19 July 2023

**Re: Building Code of Australia Inspection & Reporting Service
Premises: 678 Pittwater Road, Brookvale NSW 2100**

This BCA commentary relates to the proposed new ground floor use of the existing commercial premises located at 678 Pittwater Road, Brookvale NSW 2100.

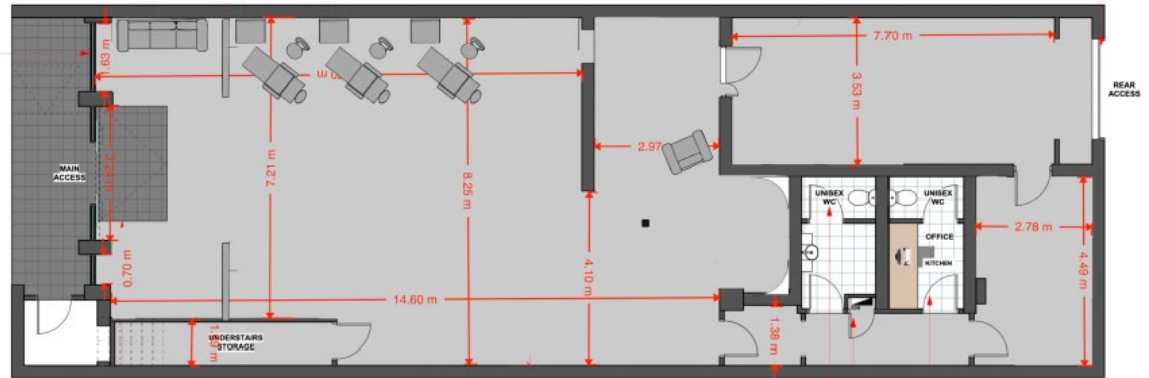
In Type C construction, the separation floor between the ground and 1st-floor residence needs a fire resistance of not less than FRL30/30/30. A concrete floor slab separates the ground floor class 6 from the 1st-floor class 4 resident use.

Provided the existing fire separation and construction conditions are maintained, the existing unit can satisfy the requirements of Part C of the BCA.

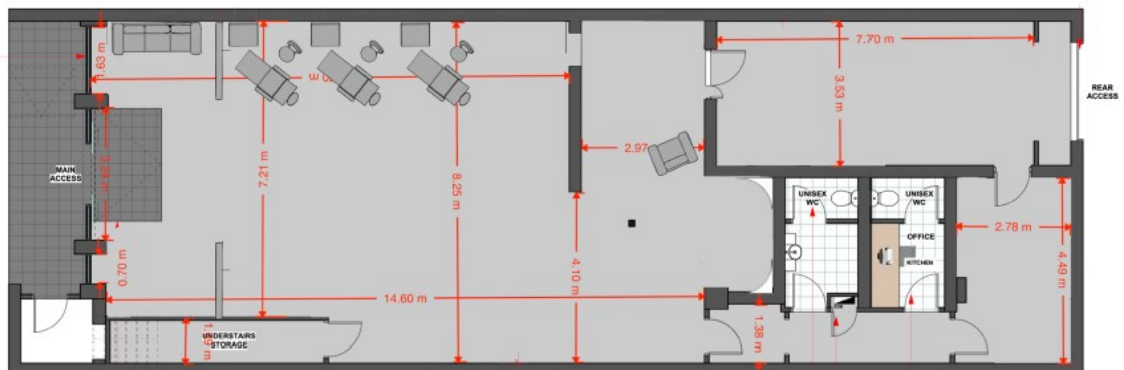
The shop will be required to upgrade to be provided with Portable Fire Extinguishers, Emergency Lights, illuminated exit and directional signage to suit the proposed new fit-out.

In terms of smoke hazard management for the proposed new use, the BCA does not require any specific additional fire safety measures.

Provided the existing fire separation and construction conditions are maintained and the existing shop is provided with the upgraded fire safety measures as required by the BCA, we are satisfied that the shop is able to comply with the requirements of Part E of the BCA.
